CHANGES FROM BASE PRODUCT BE-X005 (2099) TO AC-050 (4088)

Assembly PI Approval		Approved by		Checked by		Drawn by	
J.FULLER - 12/06/13		G.P.LTH		B.CHILDS		M.POTTER	
Angle of Projection		Units		Scale		Released	
		mm		N/A		13/06/13	
		Status		Released		Assembly Ref	
		RELEASED				AC-050	
		Part No				BE-002207-01-12

CABLE BUILDUP

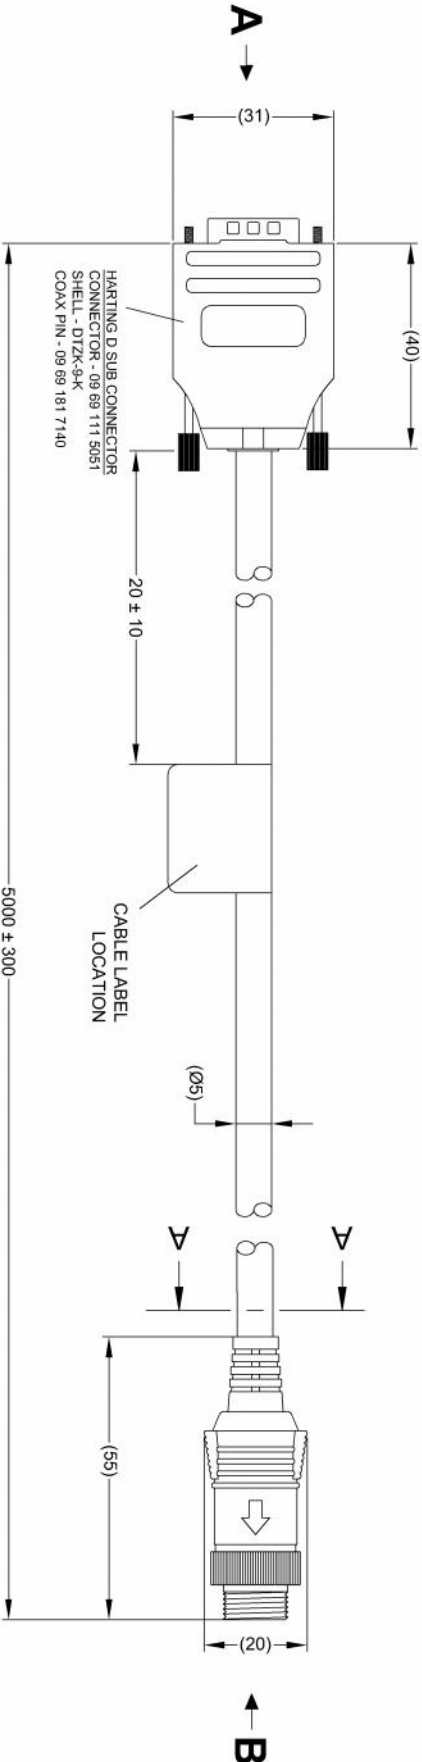
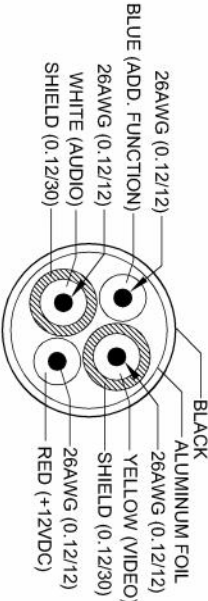
CHANGE:

1. REPLACE 4 PIN MALE CONNECTOR WITH 5 PIN MALE D-SUB CONNECTOR.
2. REPLACE BE-X005 (2099) CBL-LBL WITH AC-050 (4088) CBL-LBL.
3. REPLACE BE-X005 (2099) GB-LBL WITH AC-050 (4088) GB-LBL.
